AGENDA
La Vergne Planning Commission
May 28, 2024 at 6:00 PM

Item #: 3. Item Title: Site Plan - Dous Retail Center - Building totaling 4,200 Square Feet on 1.28 Acres. Requested by Chet Rhodes. Property located at 5130 Murfreesboro Road (Tax Map 15M, Group A, Parcel 1). C-2 (Highway Service) Zoning District. Property owned by TN Group Properties, LLC. (3rd and Final DEFERRAL)

C-4.0

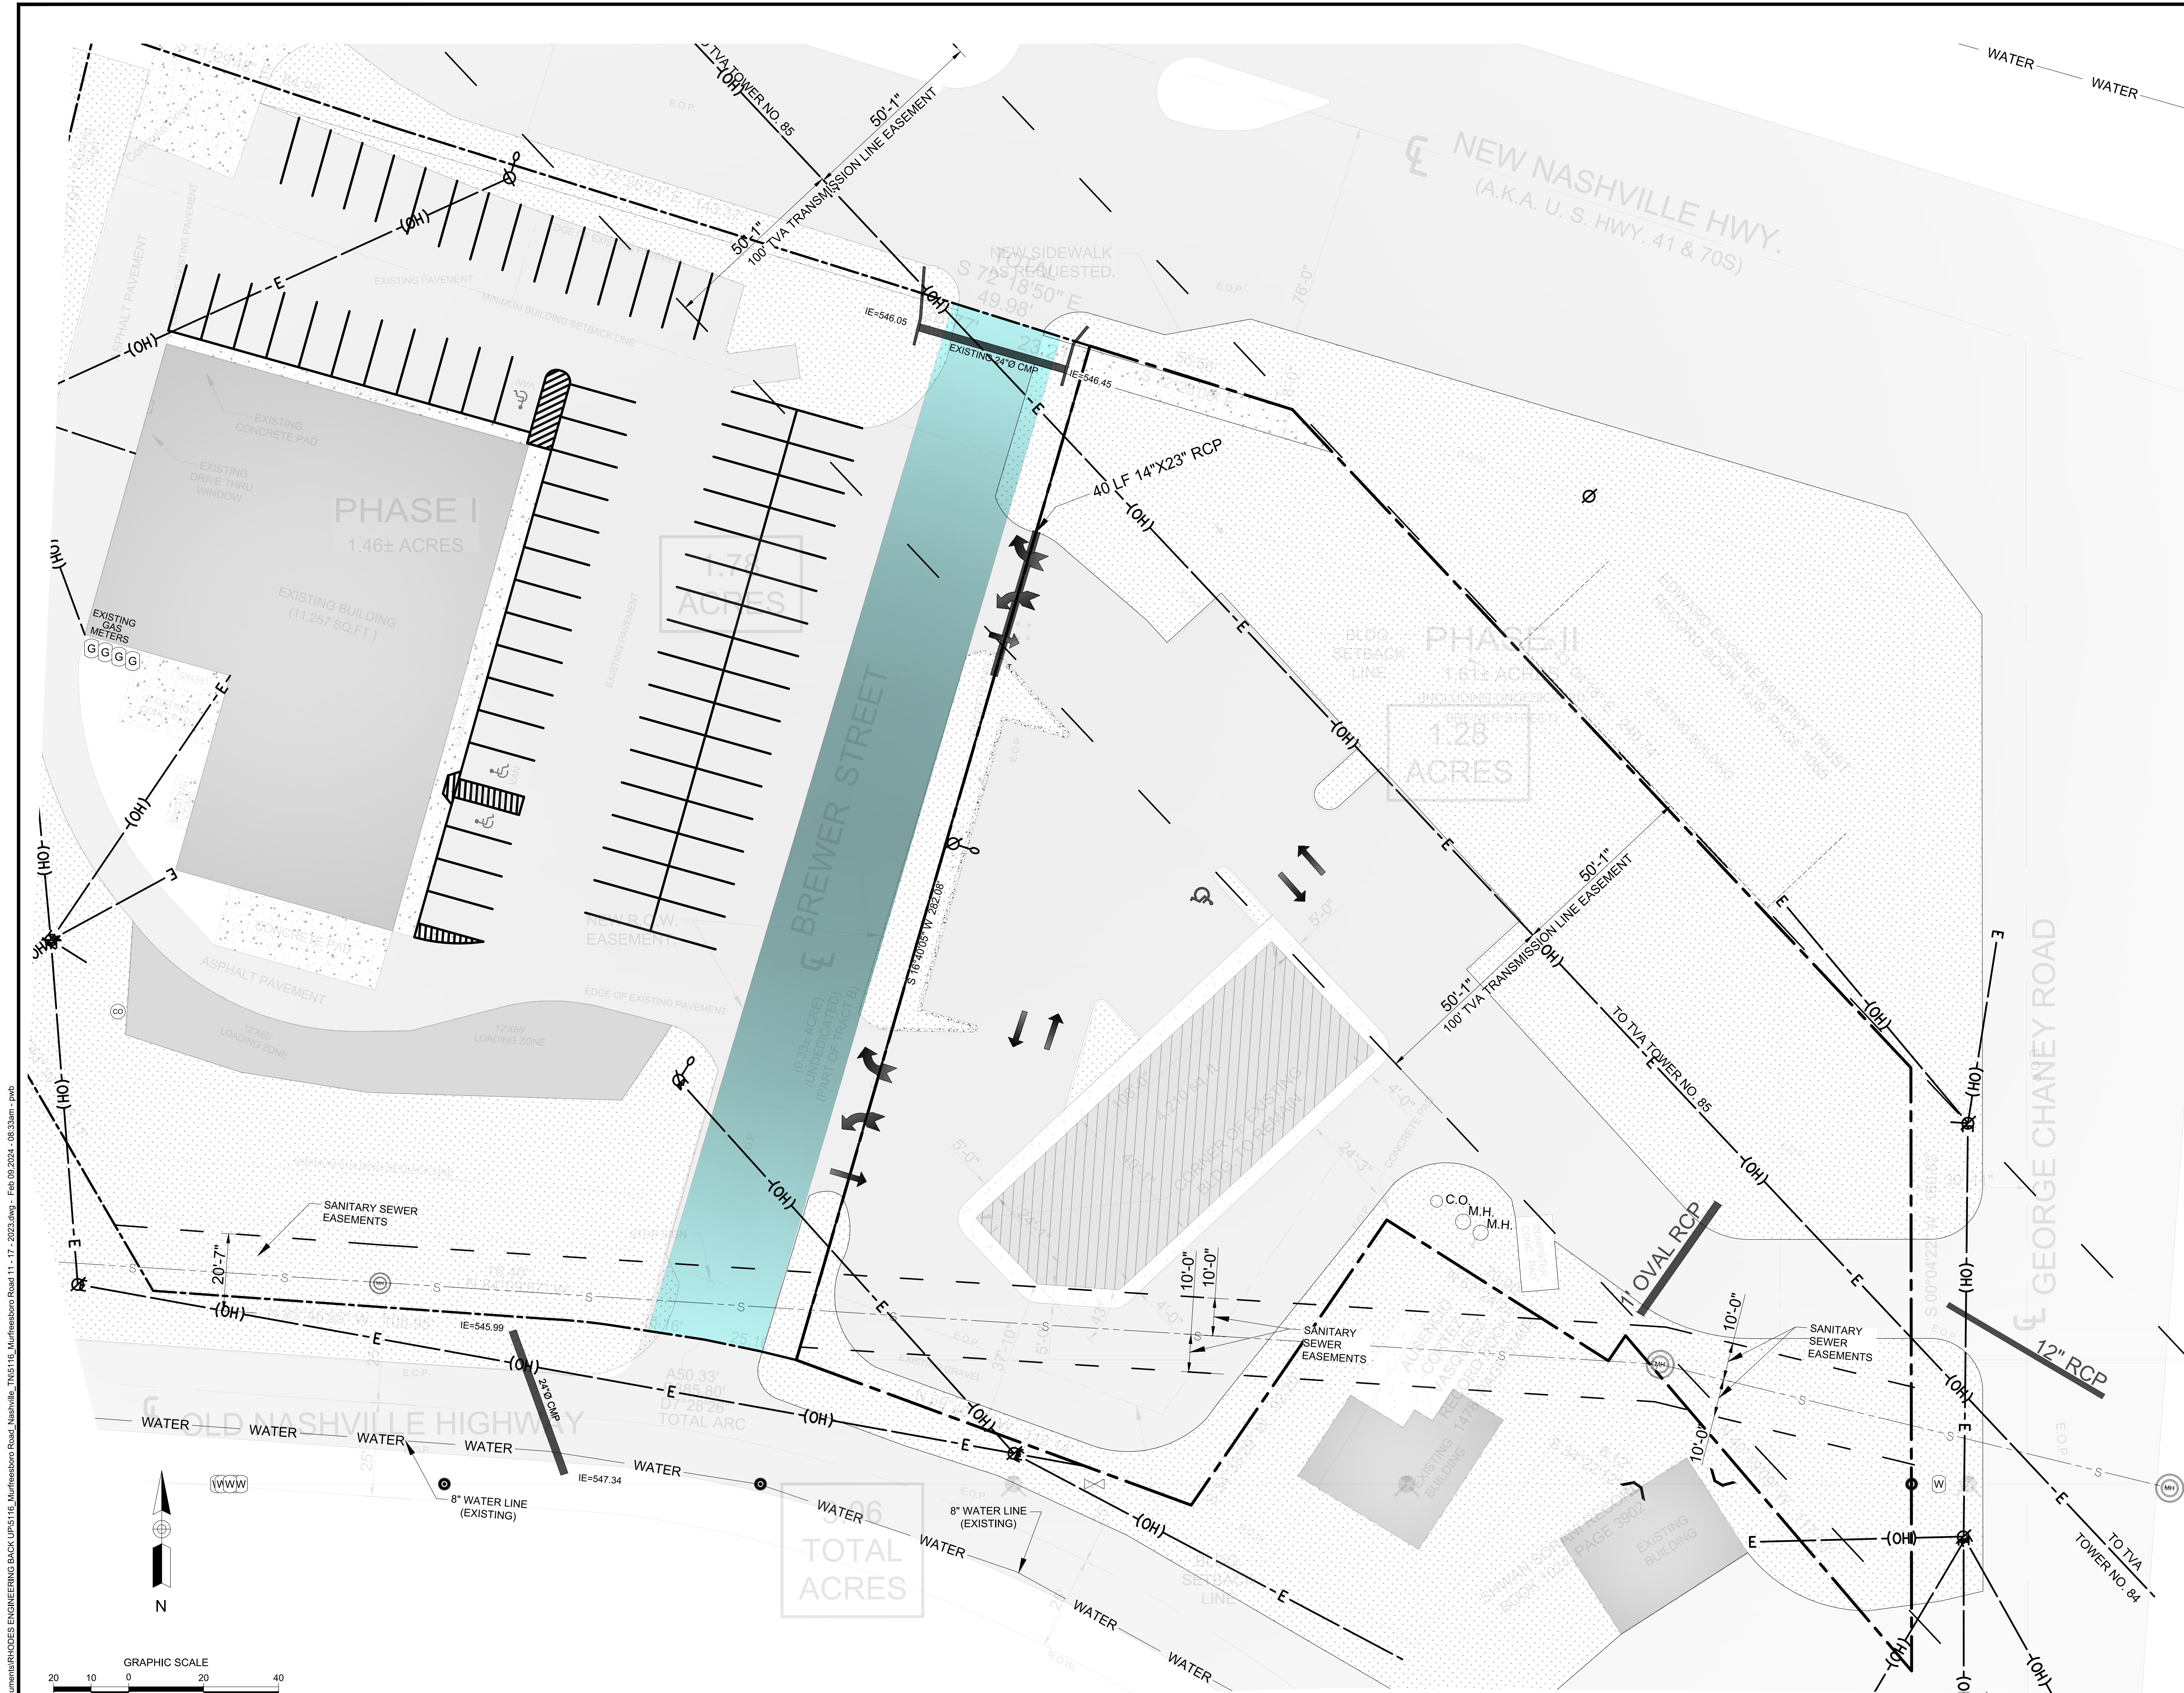
7. Provide erosion prevention and sediment control (EPSC) plans meeting the requirements of the Stormwater Management Ordinance. See Item 2 above.
8. (C-4.0) Show utilities serving proposed building even if they are existing. Engineer's response is that utilities are shown based on the survey which they were given. Staff considers the submittal incomplete.
